RAI 03.07.02-21**QUESTION:**

For SSE ground motions, 10 CFR Part 50, Appendix S requires that SSCs will remain functional and within applicable stress, strain, and deformation limits and the evaluation must take into account soil-structure interaction (SSI) effects and the expected duration of the vibratory motion. STP is a deep non-uniform soil site which is modeled with a large number of soil layers in the SSI analysis. Use of any SASSI based code for STP application must be carefully verified and validated for the project specific applications. STP had identified a numerical instability problem in the original SSI analyses using ACS SASSI NQA Version 2.2.1. In view of the identified instability with ACS SASSI, STP has decided to use SASSI 2000, Version 3.0 for SSI analyses and performed additional project specific validation for this SASSI version. However, to gain additional assurance and confidence in the SSI analysis results, the staff as part of the review of Section 3.7 STP RCOL, will perform a confirmatory analysis to verify acceptability of the design basis STP SSI analysis results for the UHS/RSWPH. As such, the applicant is requested to provide the following informatio

Figure 03.07.02-21a: Node Locations for UHS - Pump House Model Output

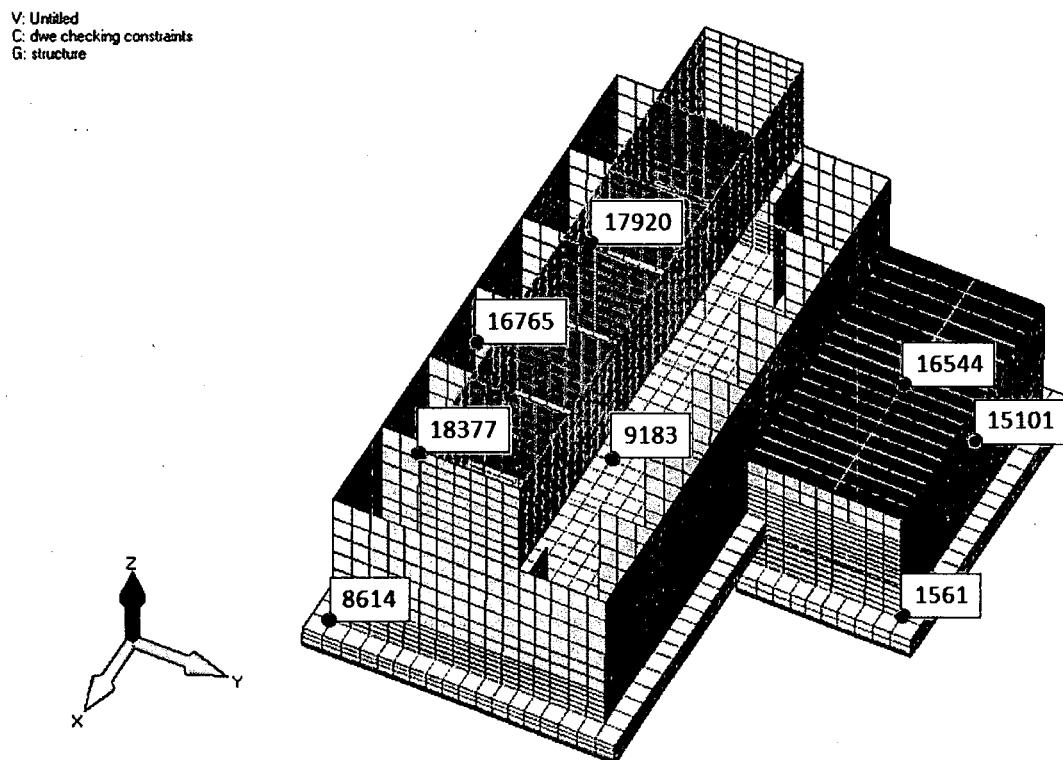
1. Electronic files of the input acceleration time histories for the SASSI analysis
2. Electronic files of the input data for the SASSI program modules: SITE, POINT3, HOUSE, ANALYS, MOTION, and STRESS.
3. The result of maximum accelerations, transfer functions and acceleration response spectra at a few selected structure nodes calculated from separate input in the x, y and z directions. The output locations should be identified by the node numbers and direction in the model and shall include nodes on the basemats, on the roofs and different wall elevations, both in the middle and at periphery of both the UHS basin and RSWPH structures.

The following locations were used for generation of output in the MOTION file. See the following Figure 03.07.02-21a for location of the nodes.

- Node 1561 Corner of pump house base slab/wall intersection,
- Node 8614 corner of basin slab, wall intersection,
- Node 9183 center of basin base slab,
- Node 15101 wall of pump house,
- Node 16544 center of pump house roof slab,
- Node 16765 mid-height wall of basin at the intersection with the buttress,
- Node 17920 mid height wall of cooling tower support structure,
- Node 18377 top corner of cooling tower support structure.

Figure 03.07.02-21c: RSW PUMPHOUSE AT EL (-)18'-0"

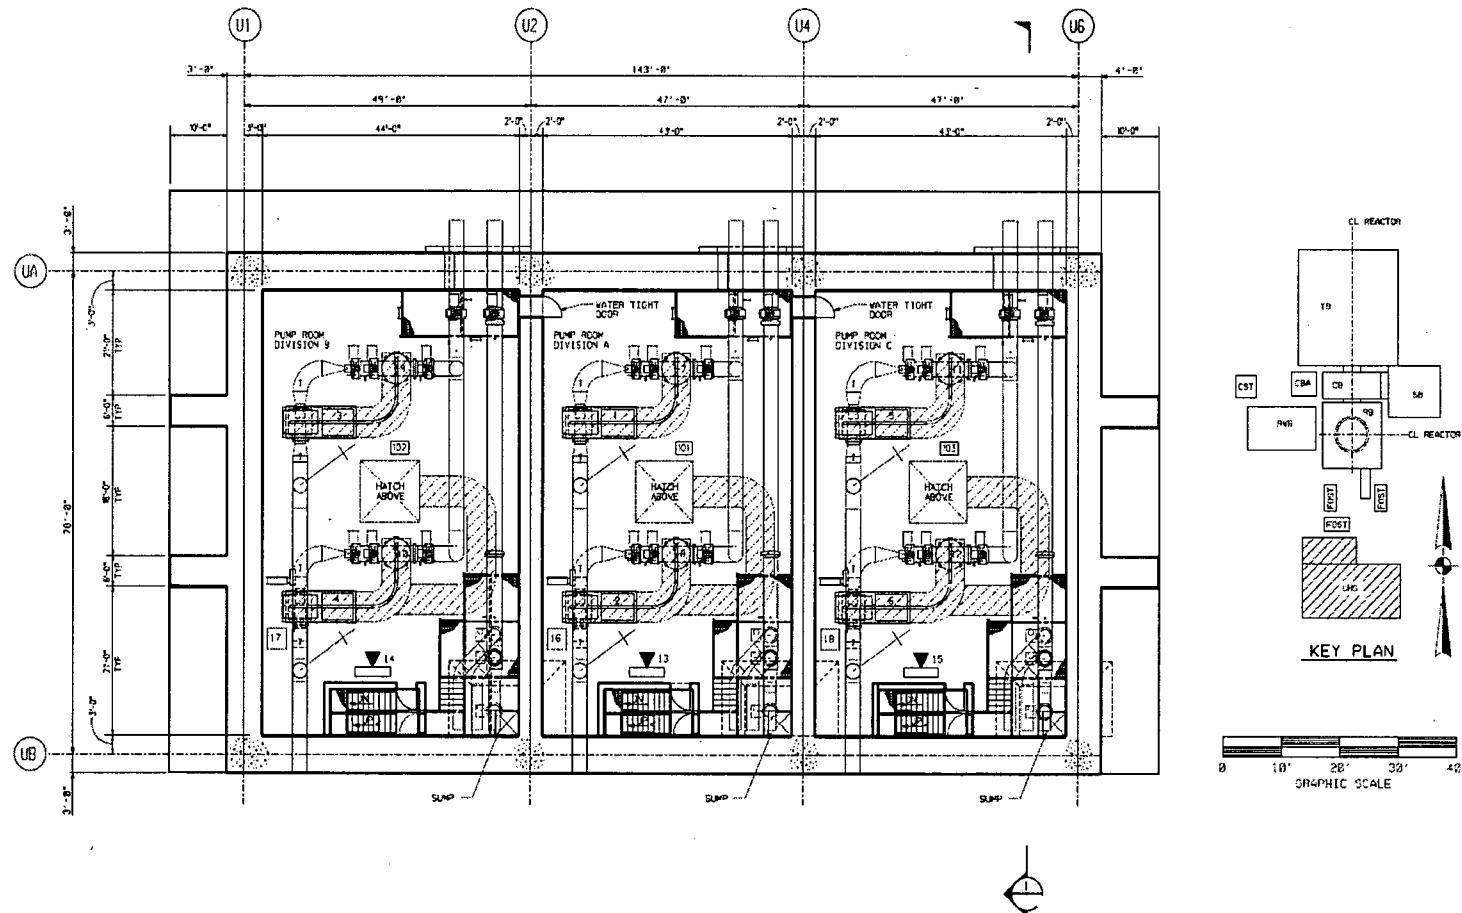
1. A sketch showing the building layout and dimensions
2. A table summarizing the layer thicknesses and properties for the mean soil case
3. A table summarizing the added mass properties for water in the basin
4. A list of frequencies used in the analysis including the cut-off frequency

1. Attached Figures 03.07.02-21c through 03.07.02-21g provide building layout and key dimensions.
2. The layer thicknesses and properties for the mean soil case are shown in the table below:
